I am the councillor for Grosvenor ward, which includes the site under consideration.

There's no doubt there's demand for a McDonalds in the Wrexham County borough area. That's not the issue - it's whether this location is the best place for such an outlet. With that in mind, I'm going to focus on the material planning objections to this proposal.

The main issue is traffic, congestion and the potential for gridlock. The highway department response dated 24/02/2020 (Copy attached as WCBC Highway response 240220) raised a number of concerns to the original planning application for a McDonalds. Some of these have not in my opinion been adequately addressed by the applicant.

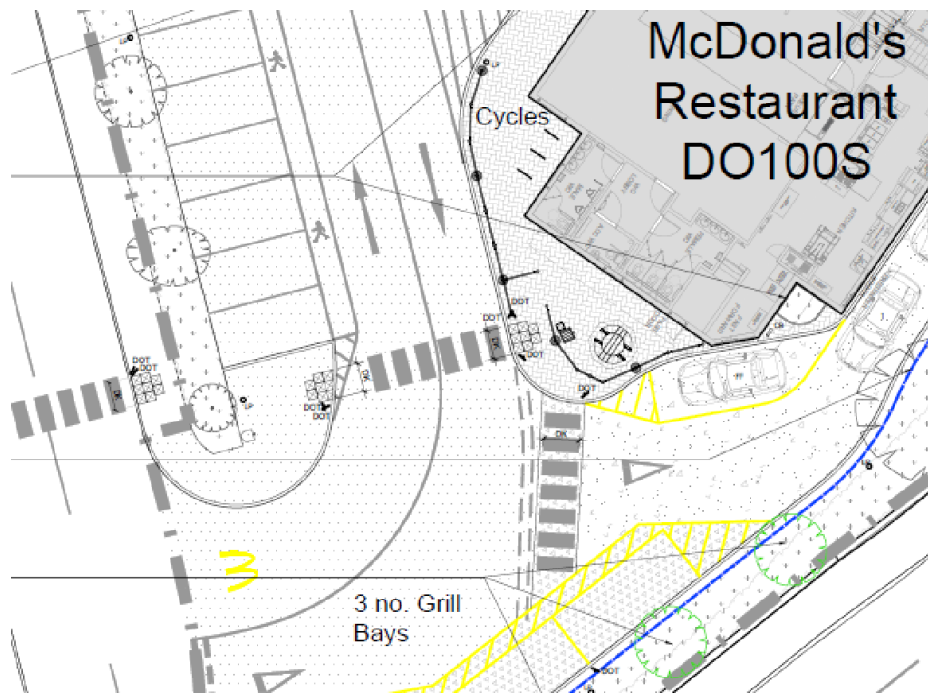
I also have concerns about the safety of the proposed zebra crossing on the access to the restaurant itself.

I'm surprised that the safety audit hasn't picked up issues with the proposed new zebra crossing directly in front of the new restaurant. It is shown in the middle of the image below just to the left of the restaurant itself.

It's virtually blind to any approaching vehicles as you are driving round a 180-degree bend and coming back on yourself. It's a very dangerous place to cross when vehicles aren't going to see you until very late. Drivers will be focused on the road not on the footways. This could cause significant highway safety issues for pedestrians, who would be at risk of vehicle collision and for drivers who would be at risk of rear end shunts as vehicles behind have to brake sharply when pedestrians are crossing.
